CFS8DL6160RF-3 FCC C2PC COVER LETTER

This letter is to inform you of our request for a Class II Permissive change we are submitting for our transceiver known as CFS8DL6160RF-3. The transceiver will continue to operate under Part 15.231.

ORIGINAL CONFIGURATION

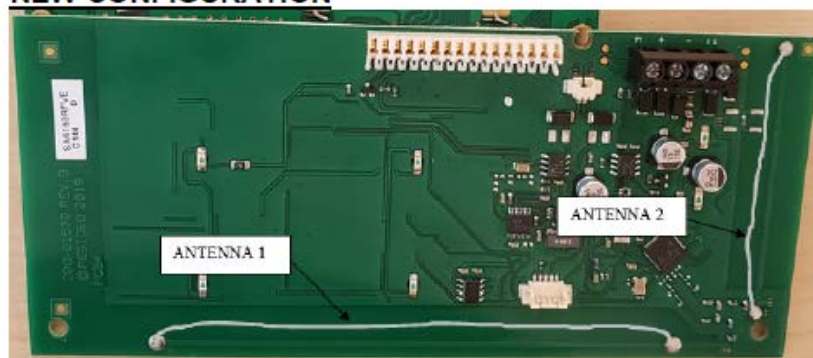
The change involves the antennas – the device is transitioning from PCB trace-type antennas to wire antennas. This change was initiated to improve the overall receive sensitivity of the device. Measurements of the fundamental along with spurious emissions and occupied bandwidth testing was performed to support the change. See before and after photos below.
